Motor News Page 1/5

May 26, 2015

# Shin-G Series Compact Geared Motors Condenser label change accompanied by production location change.

Table 1: Details of changes to condenser labels and areas changed (Photos show typical condensers.)

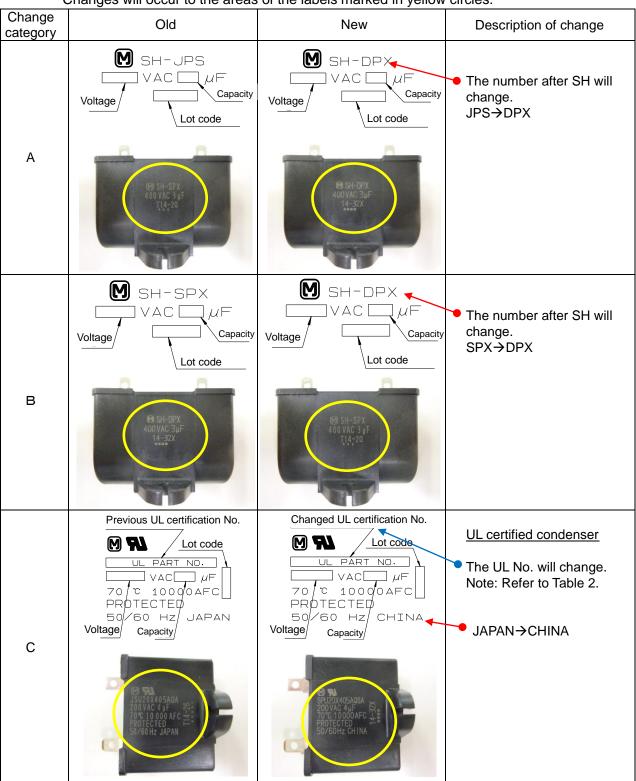
Due to the change of production location, the contents of the label will change (see Table 1).

Changes will occur to the areas of the labels marked in yellow circles.

This change applies only to label contents; there is no change to the shape, performance, or features of the condensers.
